Overall Context Map

AMENITY CHARACTER AND MATERIAL PREFERENCES
1425 MERAMEC RIVER CROSSING - I-44 / 400
AUGUST 2019 INTUITION DESIGN SVS DESIGN

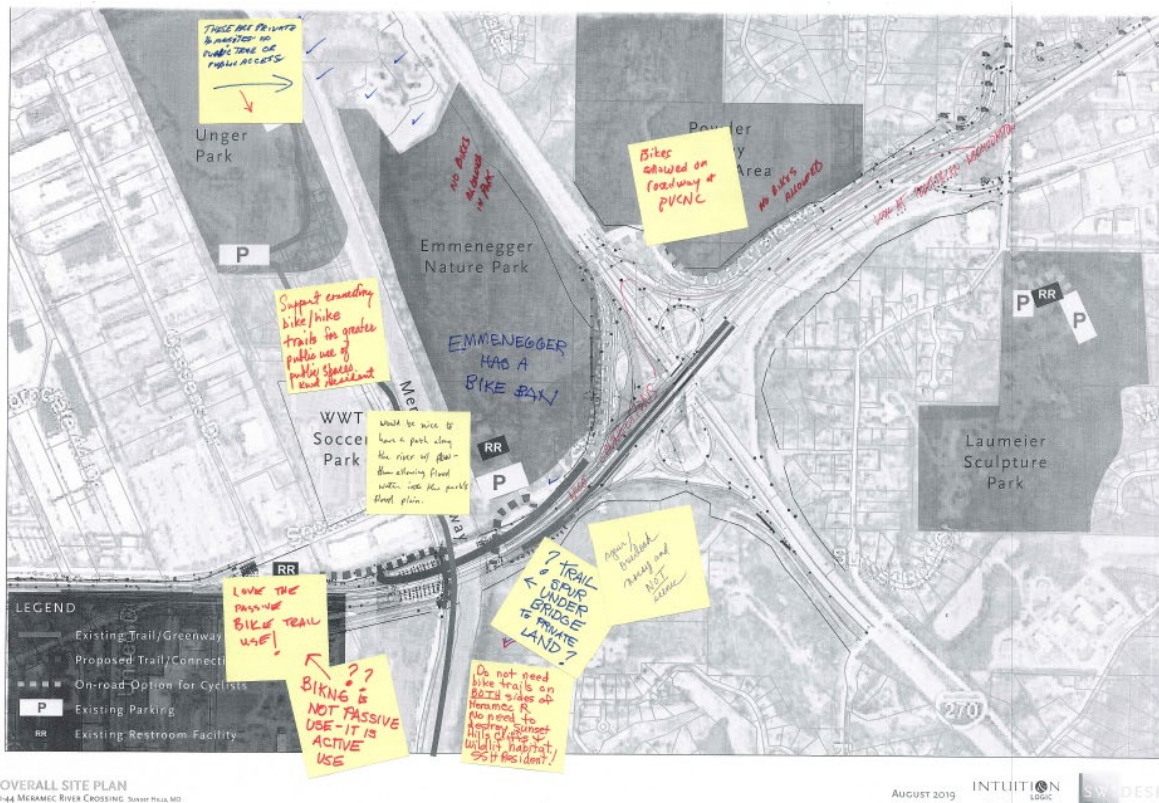
- 6 shared interest in a bridge connection between Unger Park and Greentree Park
- 3 shared support for this project and proposed connection
- 4 shared opposition to development of overlook on east side of river

- Improve the river. Even a dam downstream
- How about adding a ferry here?
- No public access on privately owned land
- No bikes in Emmenegger Nature Park

1. Crossing North of I-44 and Additional Parking

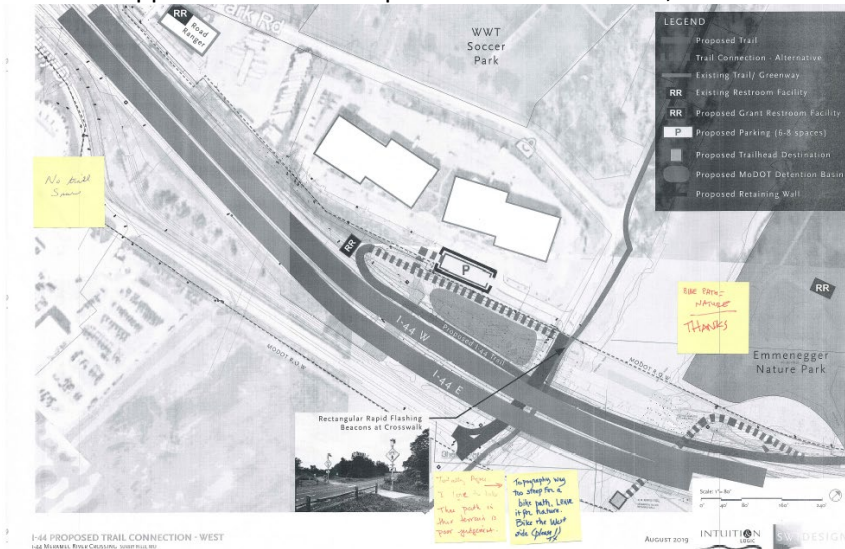
- 3 opposed to overlook spur on East side of river, concerned about steep terrain

2. Crossing South of I-44 and Spur to Road Ranger

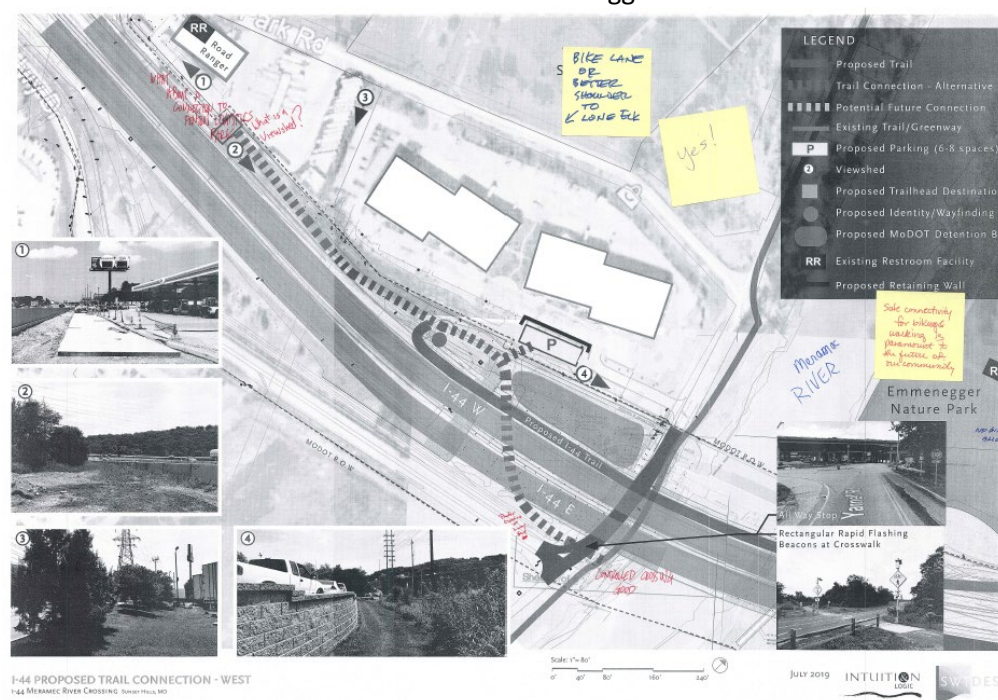
- 2 responded Yes to controlled 3-way stop crossing
- 2 requested a bike lane or shoulder along route to Lone Elk Park (starting at Soccer Park Rd.)

- “Safe connectivity for biking and walking is paramount to the future of our community.”
- Suggestion for a connection to Fenton Logistics Park
- Reminder no bikes are allowed in Emmenegger Nature Park

1. Gravel Trail to riverside landing/Trailhead with parking

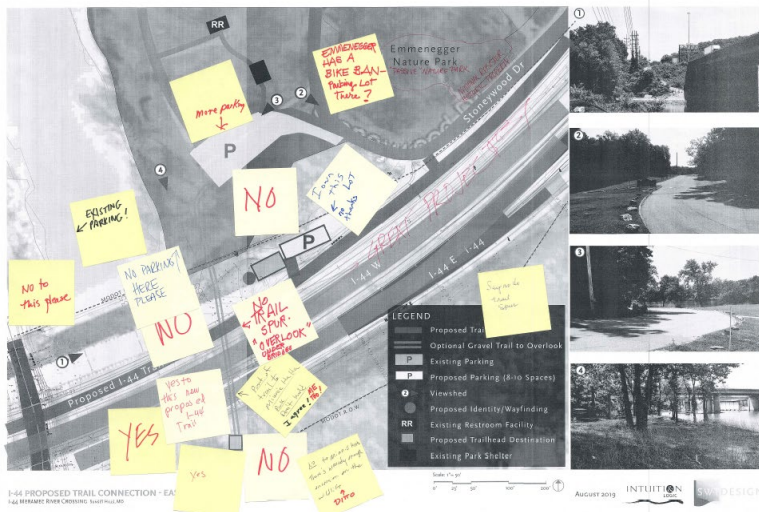
- 2 responded No to trail spur overlook
- 5 responded No to a full connection to Minnie Ha Ha Park
- 3 responded No to general plan
- 4 responded Yes to general plan
- 1 responded Yes to additional parking

1. Parking/Trailhead and on-road connection

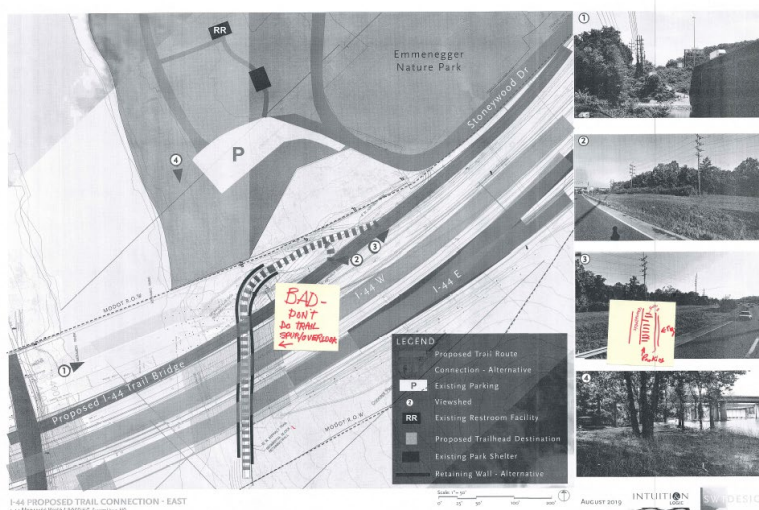
- Request for no parking along river's edge at Emmenegger Nature Park
- Opposition to development from owner of land between MODOT R.O.W. and Emmenegger Nature Park

- 1 opposed to trail spur overlook
- Sketch showing head-in parking off of Stoneywood Drive
